**Monitoring Year 3 FINAL Monitoring Report**  
**Stewarts Creek Tributaries Stream Restoration Project**  
**Surry County, North Carolina**  
**Yadkin River Basin, Hydrologic Unit Code (HUC) 03040101**

**RE: Response to Draft Monitoring Year 3 report for the Stewarts Creek Tributaries site Yadkin River Basin – CU# 03040101 – Surry County DMS Project ID No. 100023. Contract # 7183**

**RE: Response to Draft Adaptive Management Plan Comments dated May 26, 2022  
Stewarts Creek Tributaries Stream Restoration Project  
Yadkin River Basin –HUC 03040101 – Surry County, North Carolina  
NCDMS Project # 100023, Contract # 7183**

## Stewarts Creek Tributaries Stream Restoration Project Year 3 (2022) Streamflow Data

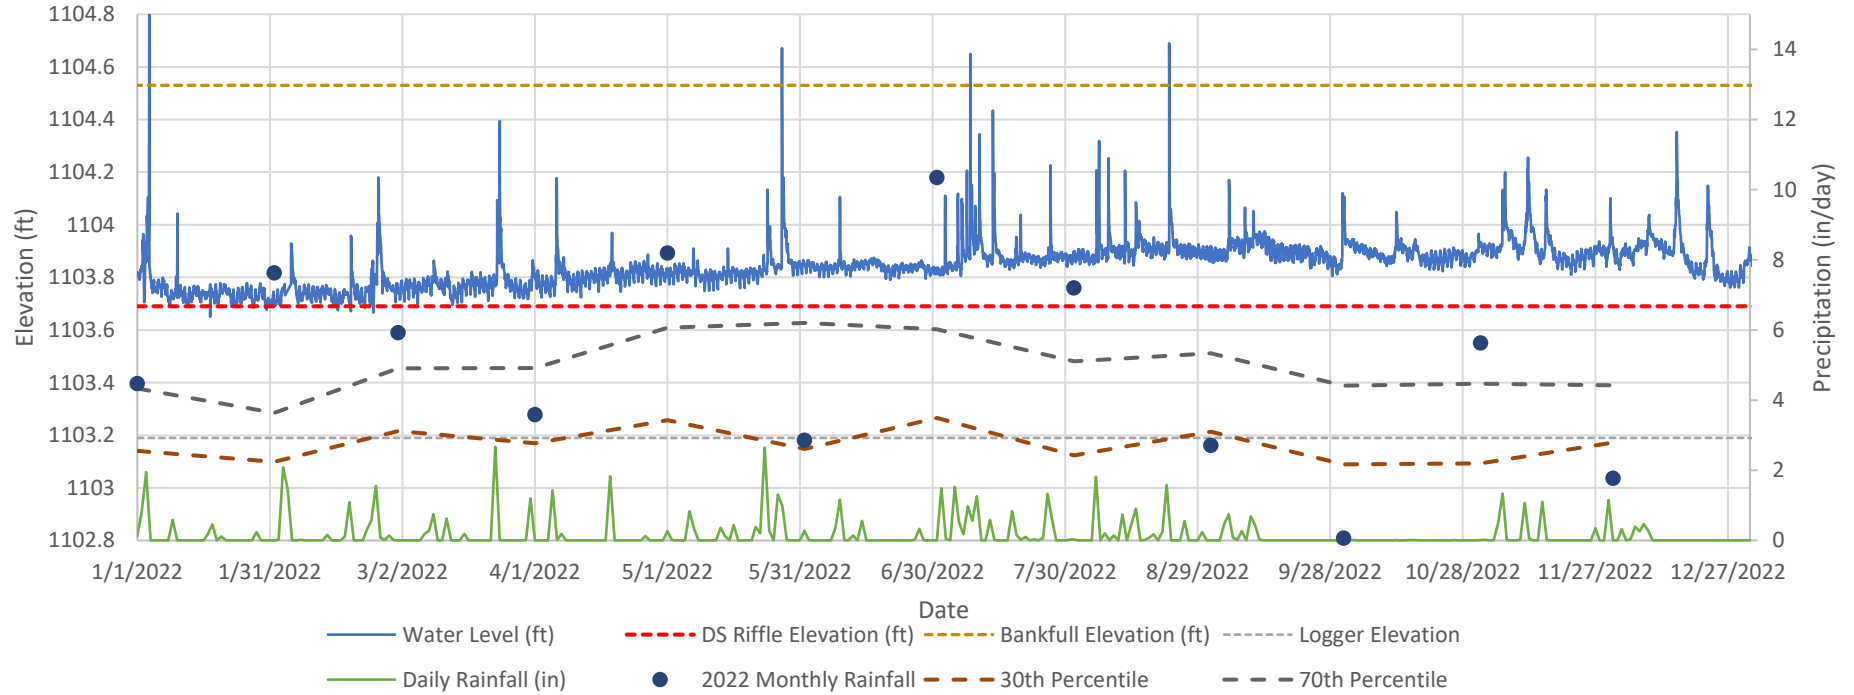
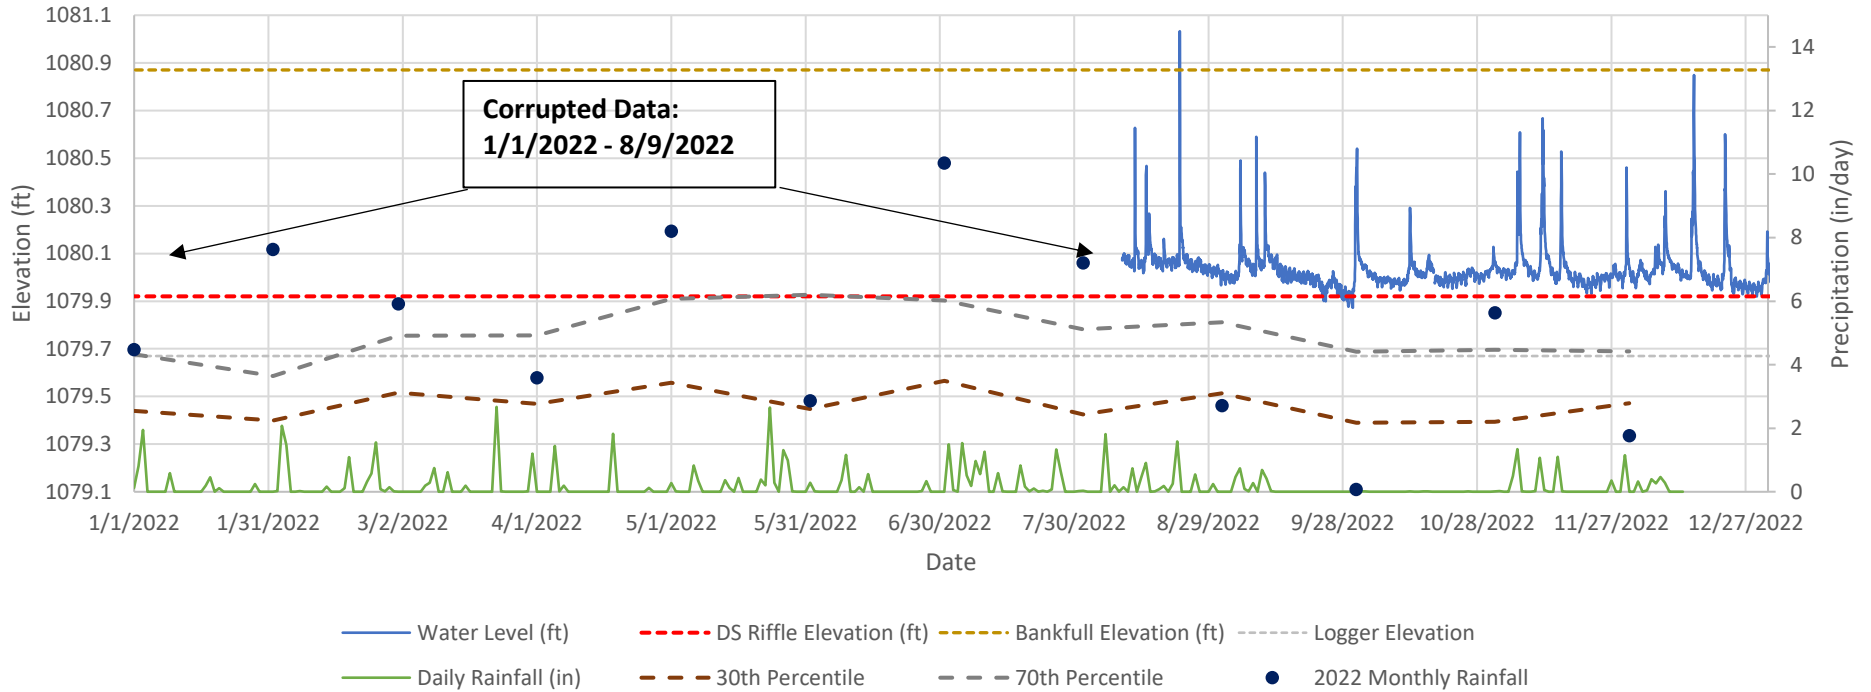
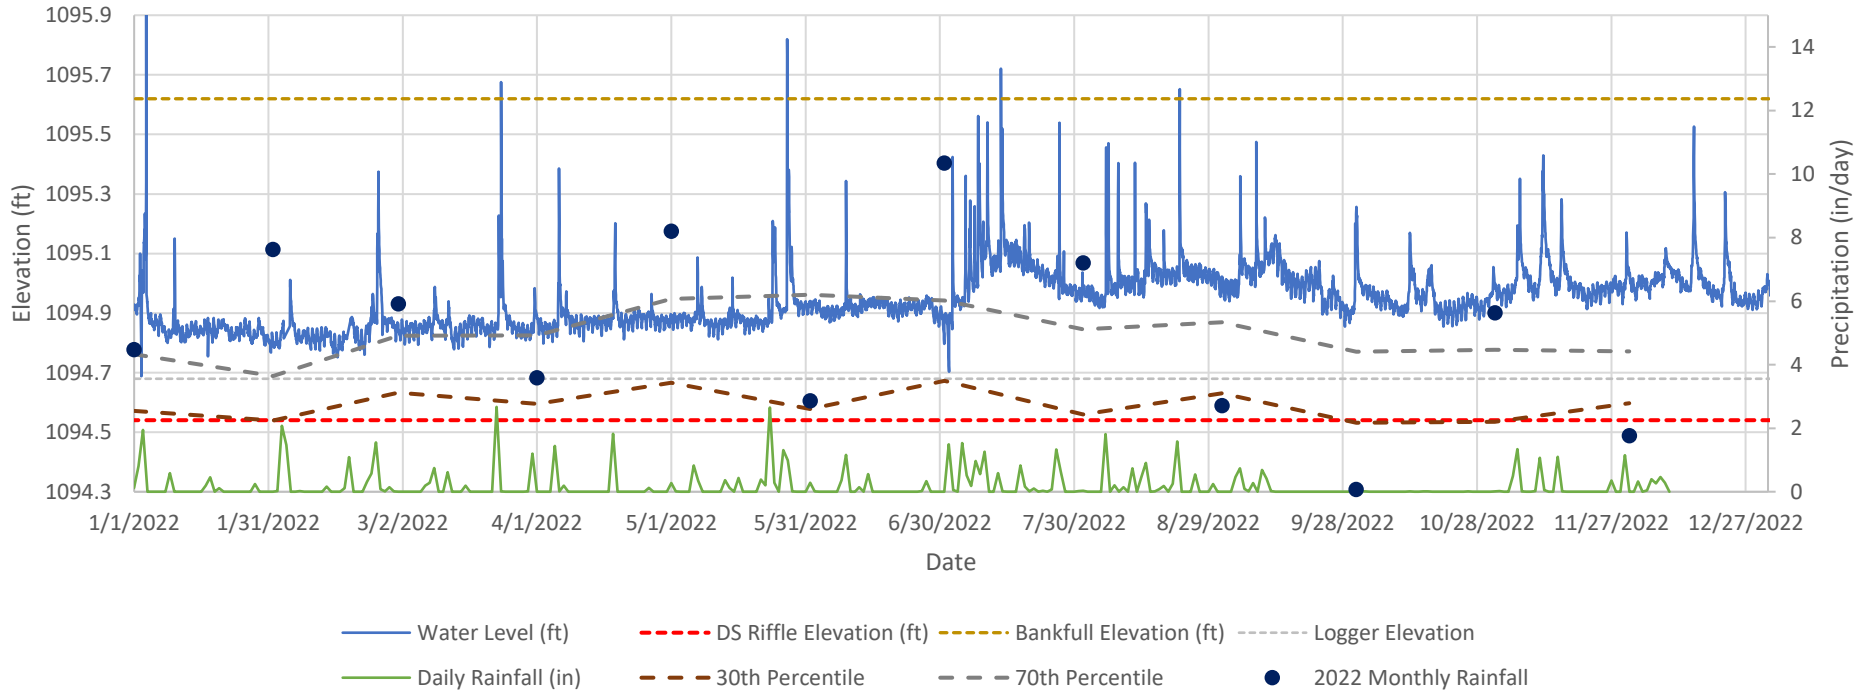
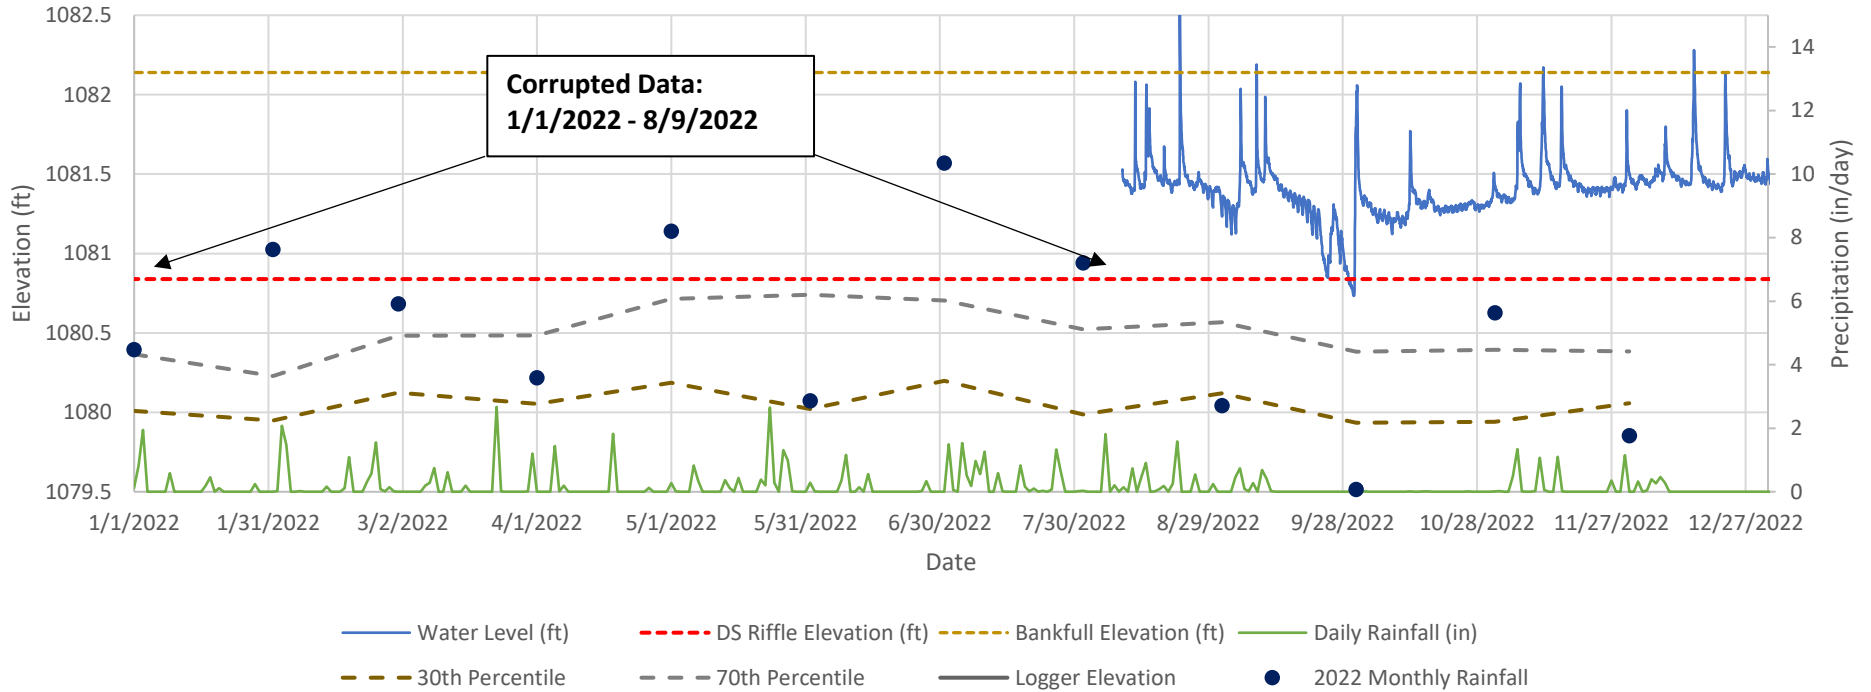
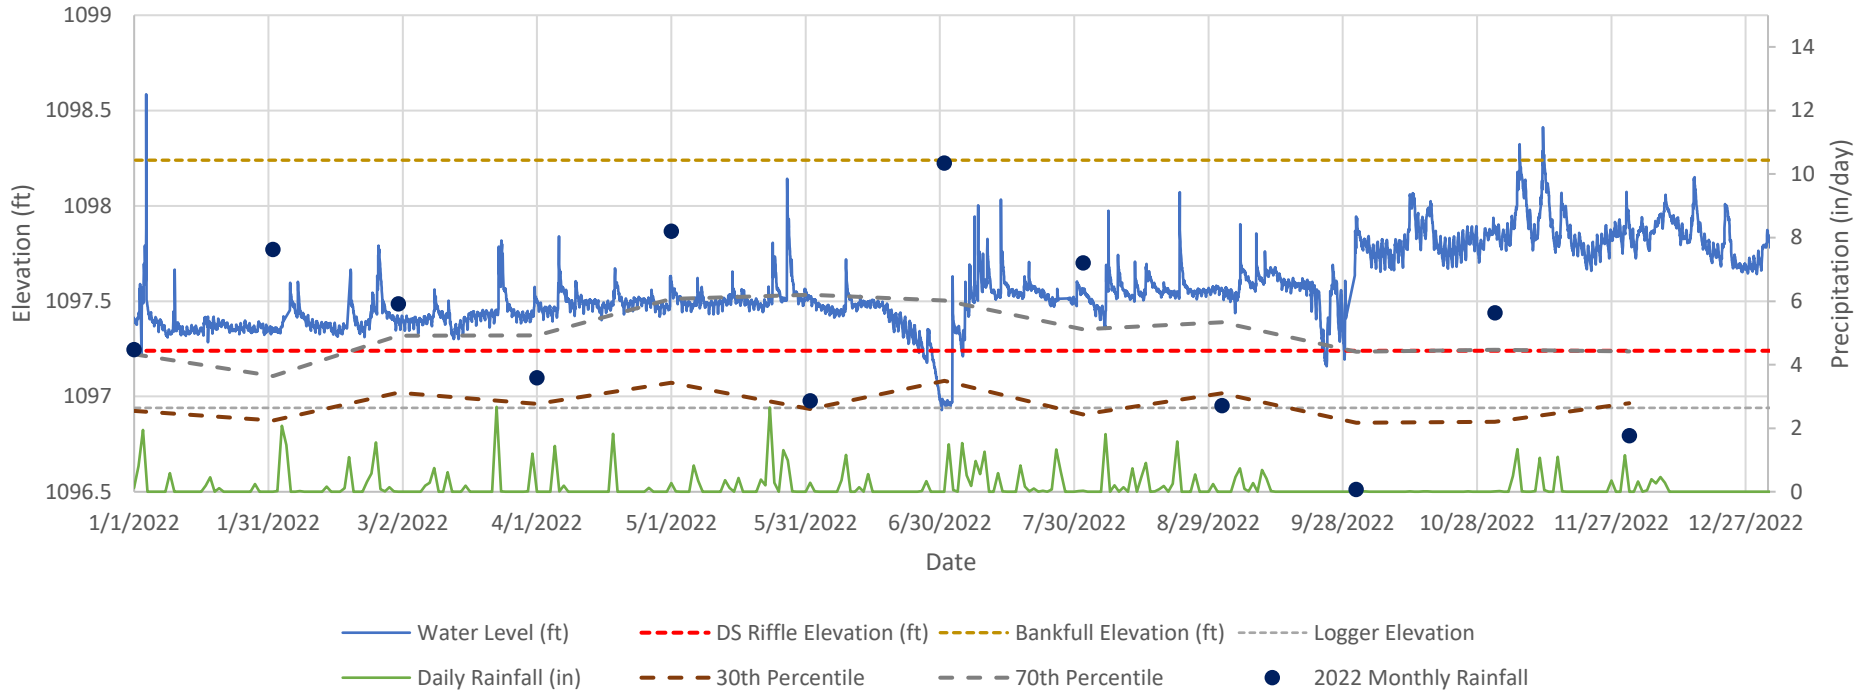
- **Included.**
- *Section 1.2 Performance Criteria: Please review and update NCDED to NCDEQ.*
  - **Updated.**
- *Appendix D: Hydrologic Data - Year 3 (2022) Streamflow Data: Please provide a streamflow data summary table across all years of monitoring in the revised report. In the streamflow data graphs, please include call outs that identify the start and end dates of the most consecutive days of flow reported for each gauge. Several of the graphs report consecutive days of flow that do not appear to be accurate. As an*

*example, SCTSG3 reports 365 days for consecutive flow; however, there are several instances that show the water level dropping below the DS Riffle Elevation. Please explain in the response to DMS comments letter and update the graphs and final report as necessary.*

- **Streamflow Summary Data added to Appendix D in Table 11. The consecutive flow days are accurate. The noise in the data was on every graph and is due to a few erroneous points in the barometric data. This noise does not last more than a few hours and has been removed to reduce confusion. Notes on the graphs have been added to each streamflow graphs for dates of consecutive days of flow and the removed inaccurate data. There is other noise on the graphs for the data that still appears less than the downstream riffle elevation, but these points last for only an hour and are in tolerance (0.1 foot) of the downstream riffle elevation.**
